TOWN OF WILTON
ADDENDUM NO. 2

RFP #2022-09

**Request for Proposal to Replace Lovers
Lane Bridge - Bridge #04975**

ADDENDUM NO. 2

DRAWING NO. S-21
 SHEET NO. 04.21.A2

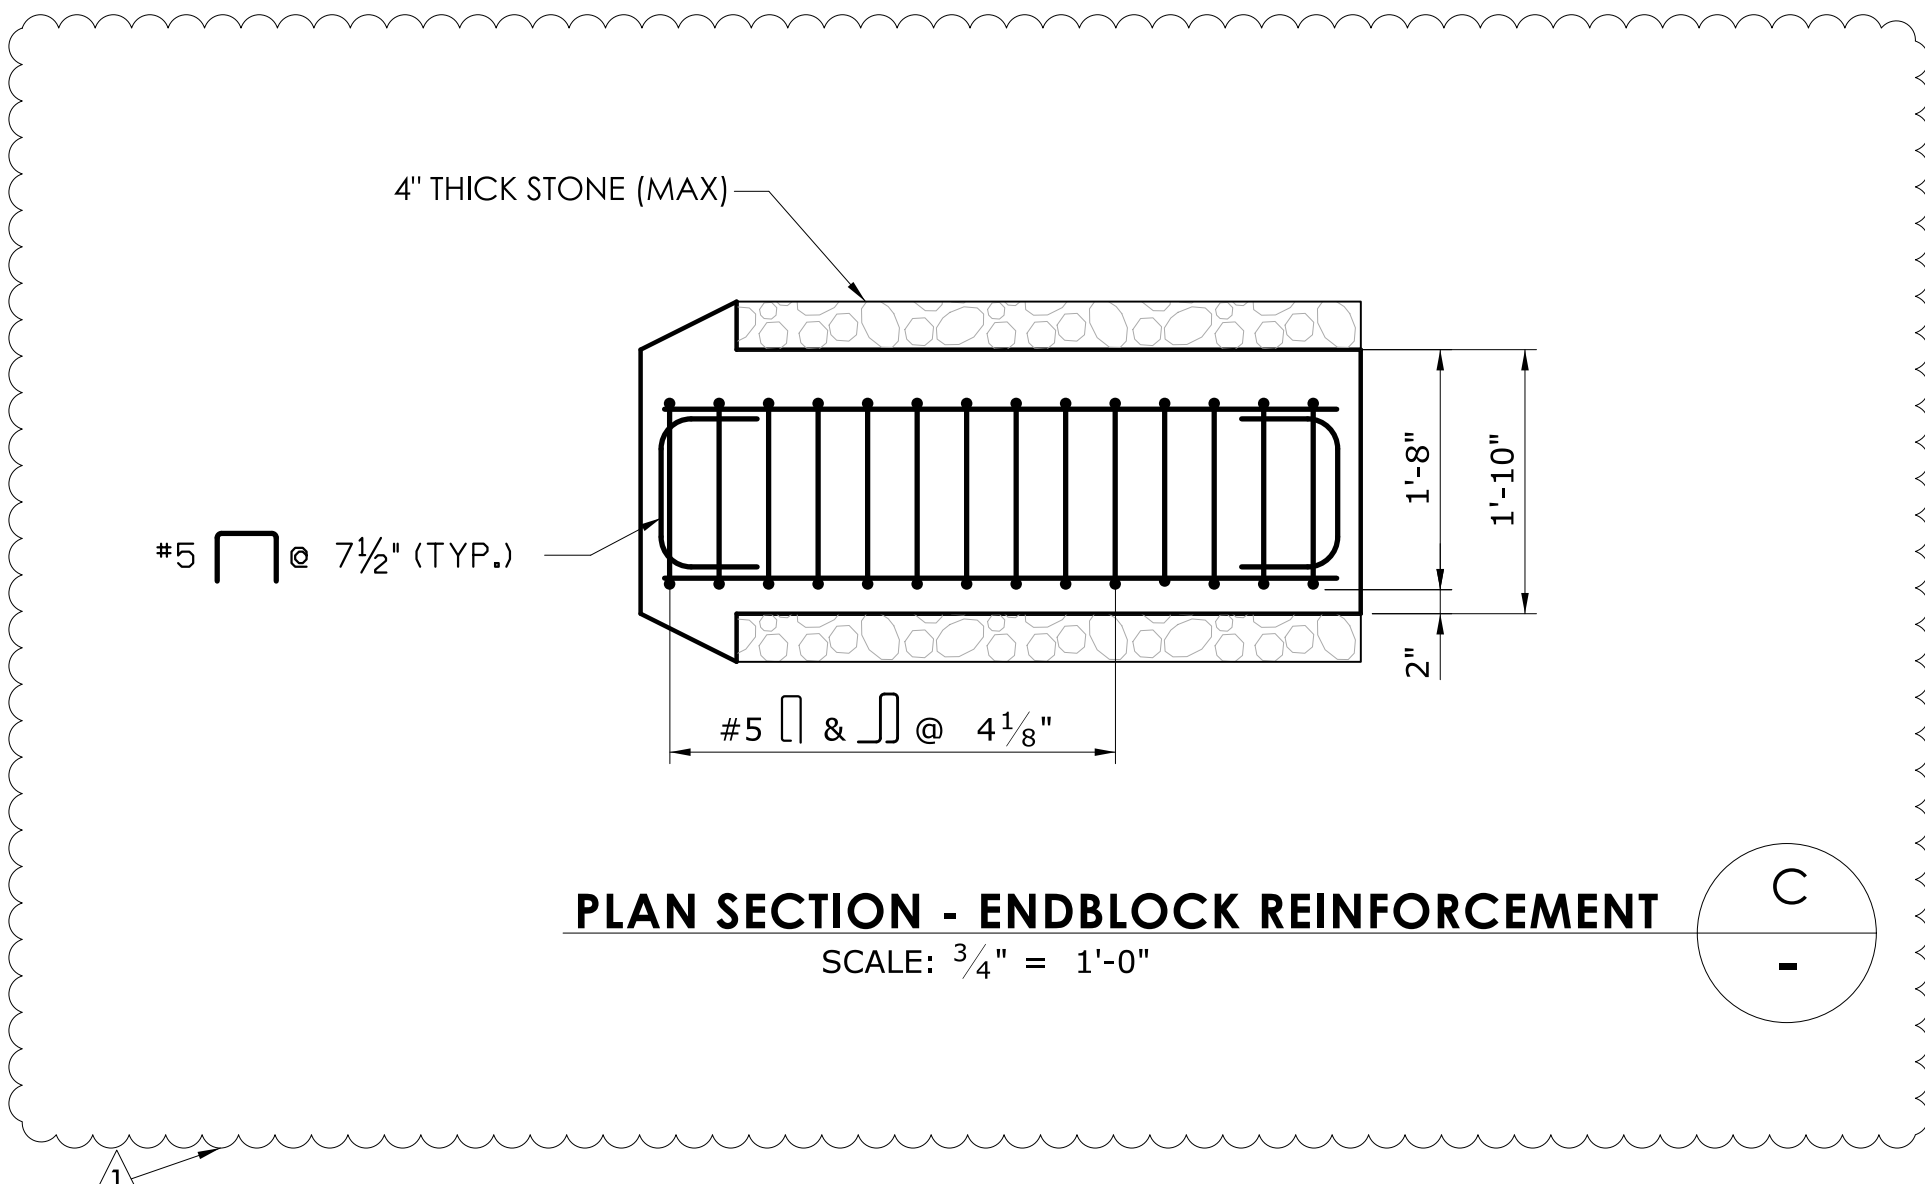
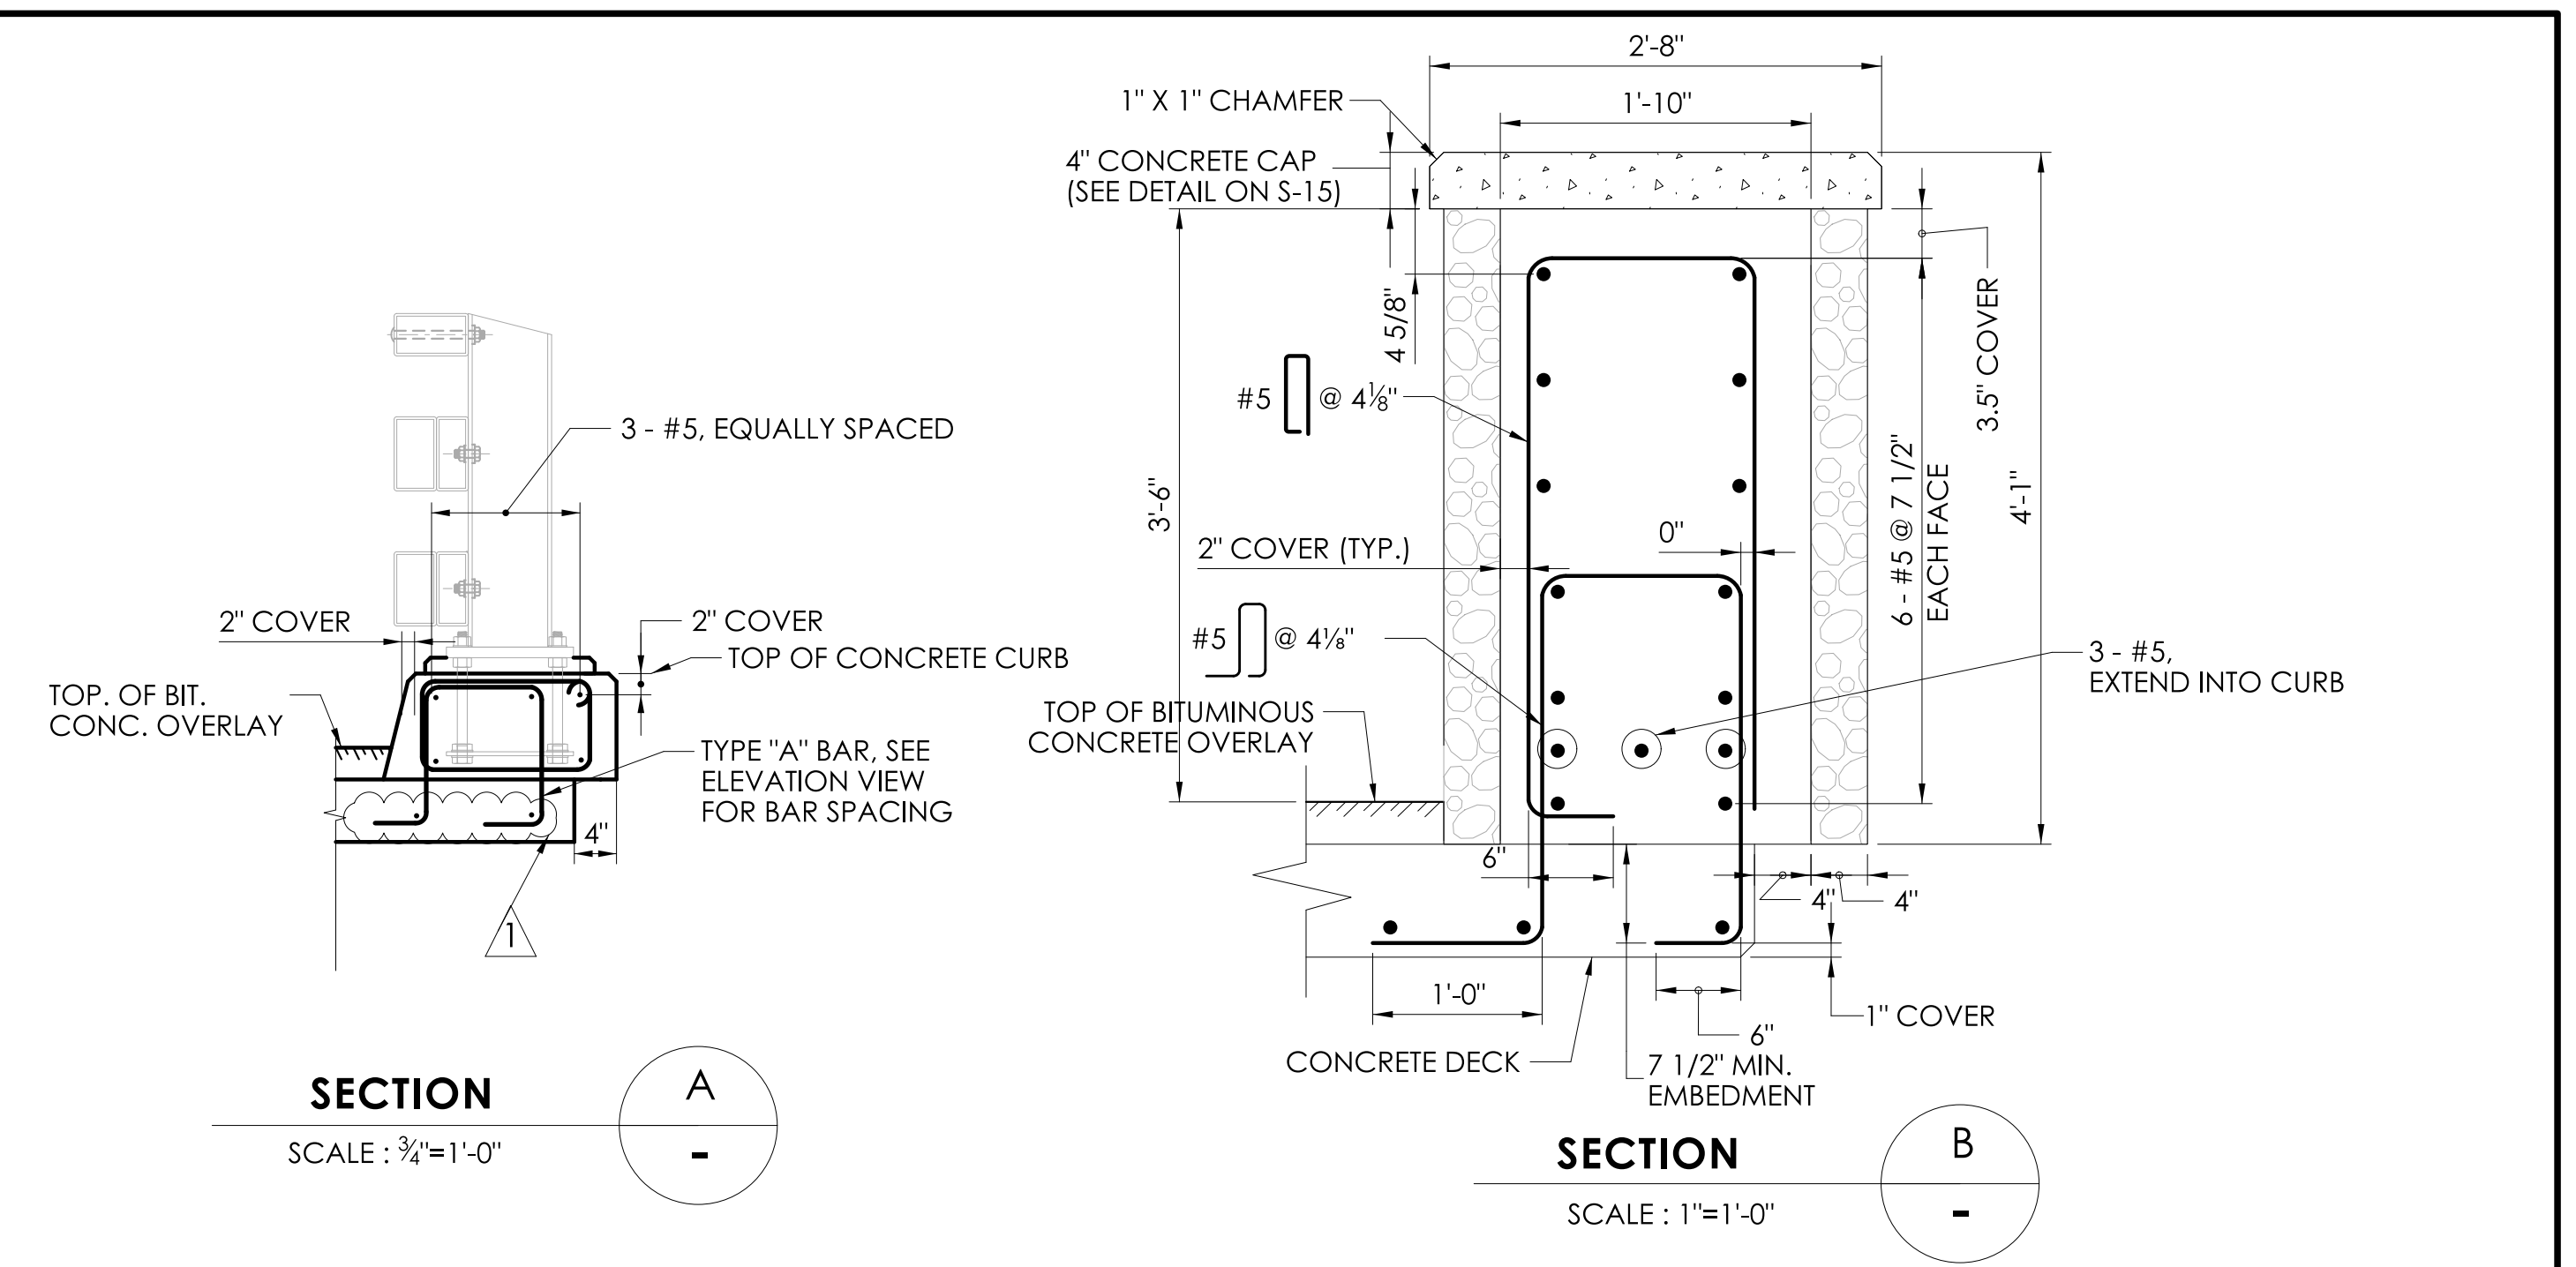
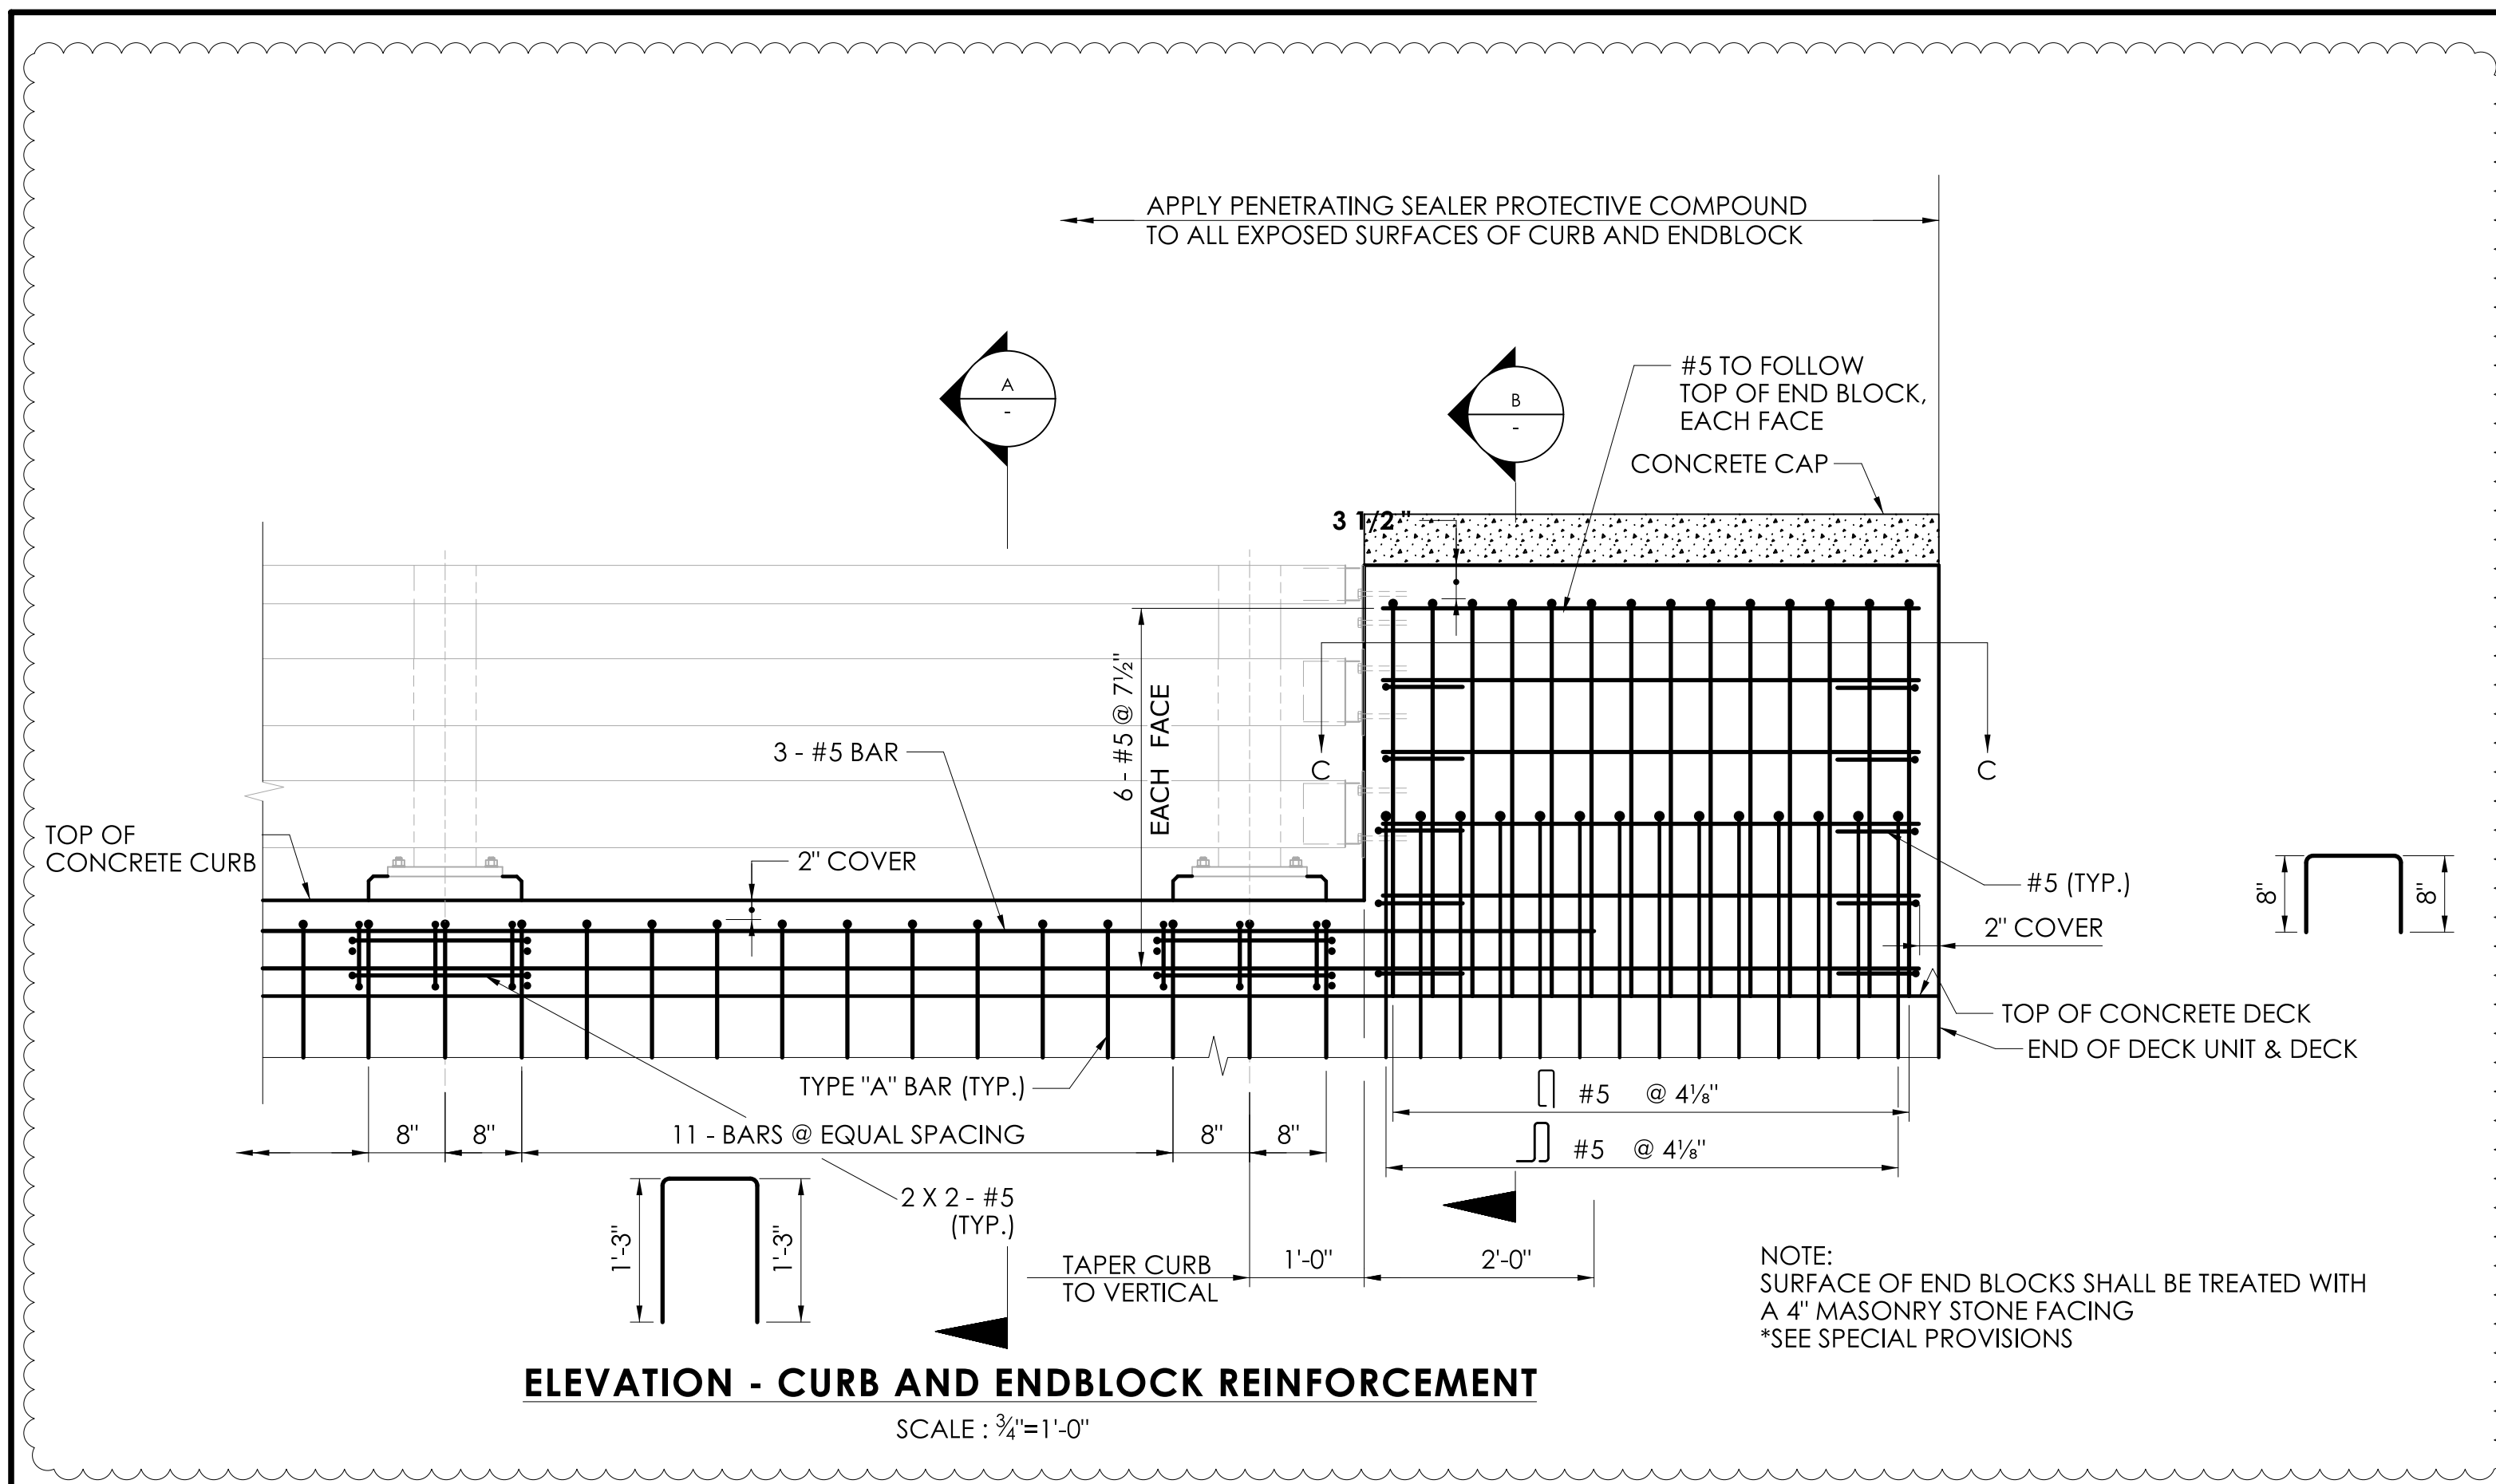
REV.	DATE	REVISION DESCRIPTION
1	12/15/22	CONCRETE CAP MODIFICATION

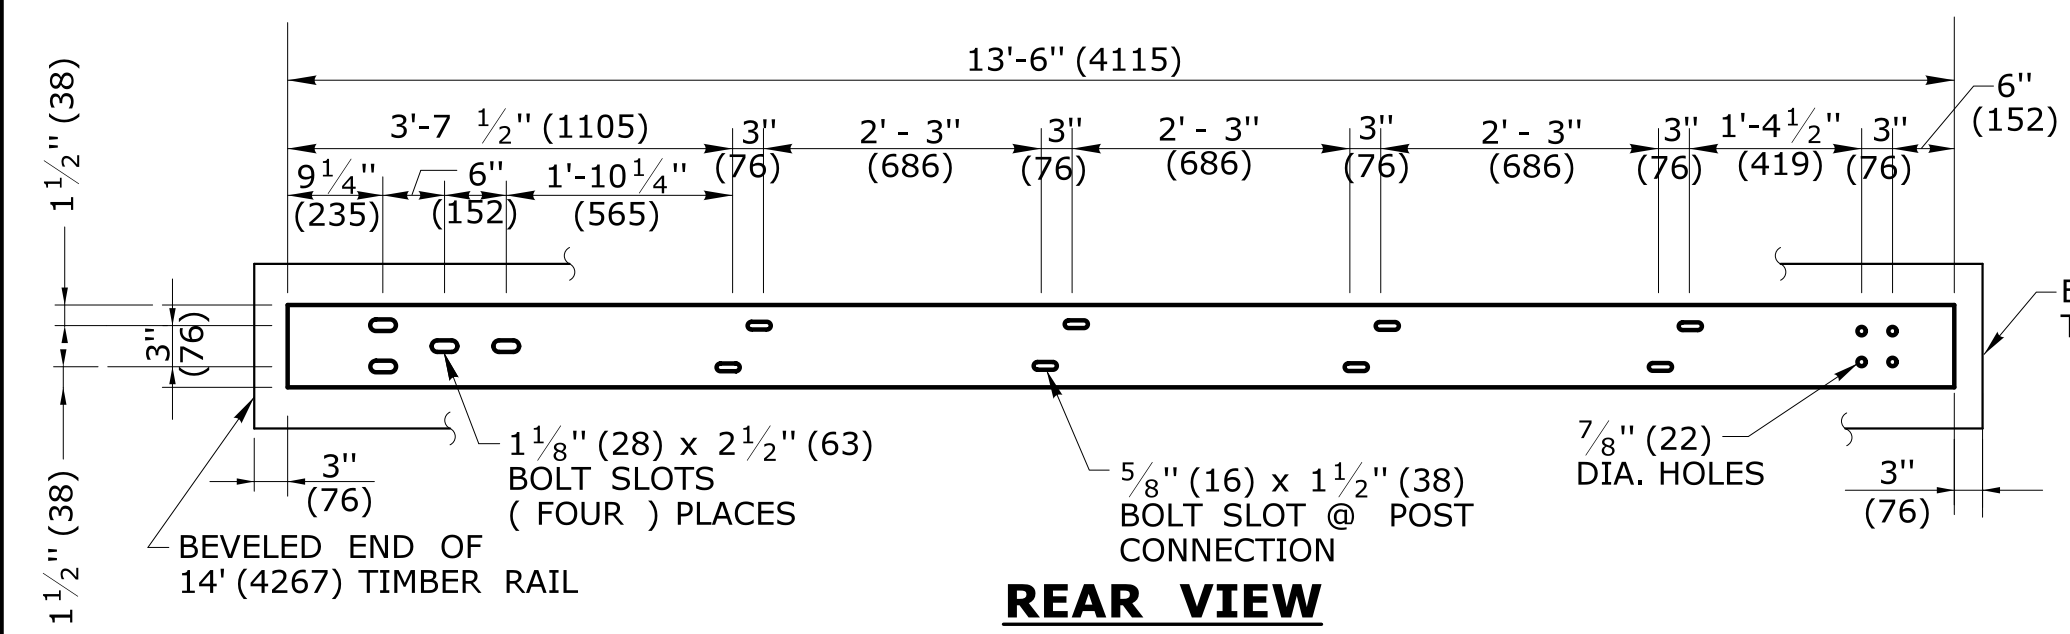
REV.	DATE	DESCRIPTION
1	12/15/22	ENDBLOCK MODIFIED
		REVISION DESCRIPTION
